AMENDMENTS TO THE DRAWINGS:

Serial No. 10/734,214 In re Office Action dated February 10, 2006 Amendment dated May 10, 2006

Appl. No. 10/734,214 Amdt. dated May 10, 2006 Reply to Office Action of February 10, 2006 Annotated Sheet

Fig. 1

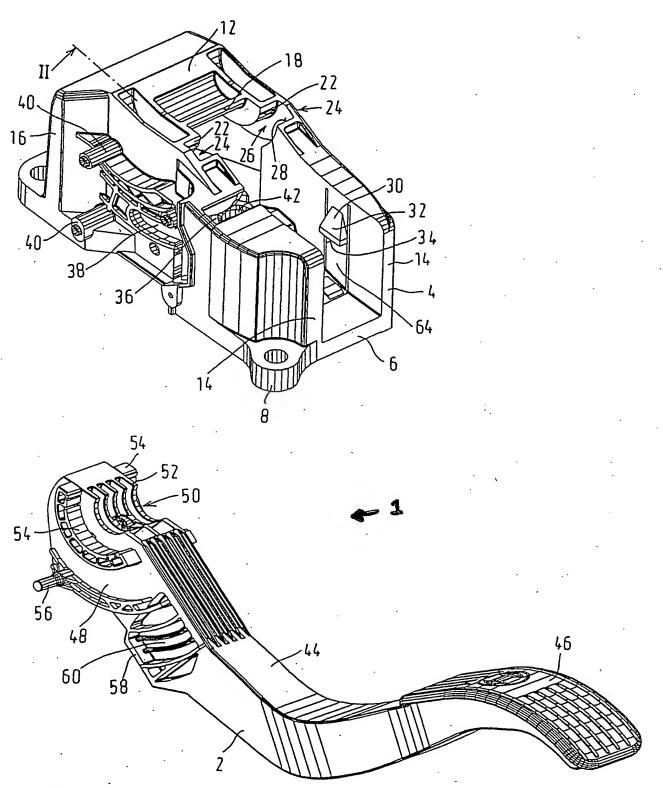
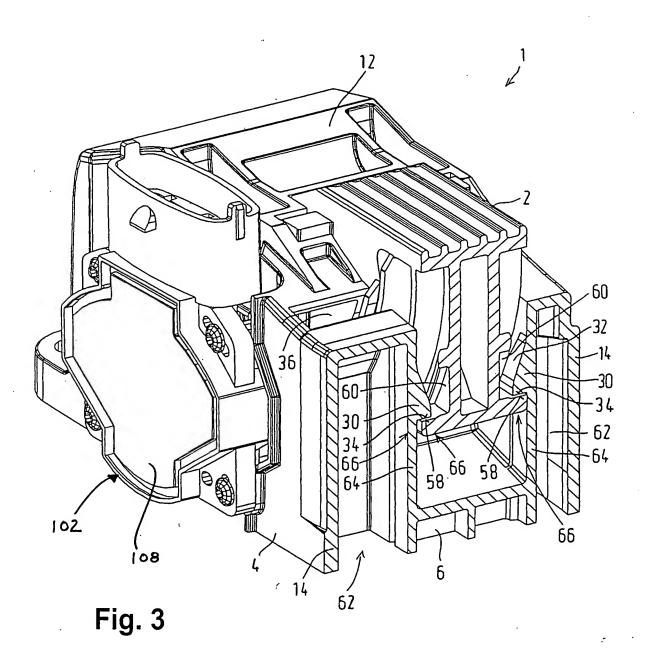
The examiner has objected to the drawings as failing to comply with 37 CFR 1.84(p)(5) because they are missing the following reference numerals: reference numeral 1 is missing from Fig. 1; reference numeral 30 is missing from Fig. 2; and reference numeral 90 is missing from Fig. 7. Substitute sheets of drawing are included in this amendment incorporating the required changes. With regard to reference numeral 30 missing from Fig. 2, the specification has been amended to clarify that reference numeral 30 is shown in Fig. 1.

The attached sheets of drawings include changes to Figs 1, 3, and 7. These sheets replace the original sheets of Figs. 1, 3, and 7. In Fig. 1, previously omitted reference numeral 1 has been added. In Fig. 3 previously omitted reference numerals 102 and 108 have been added. In Fig. 7, previously omitted reference numeral 90 has been added.
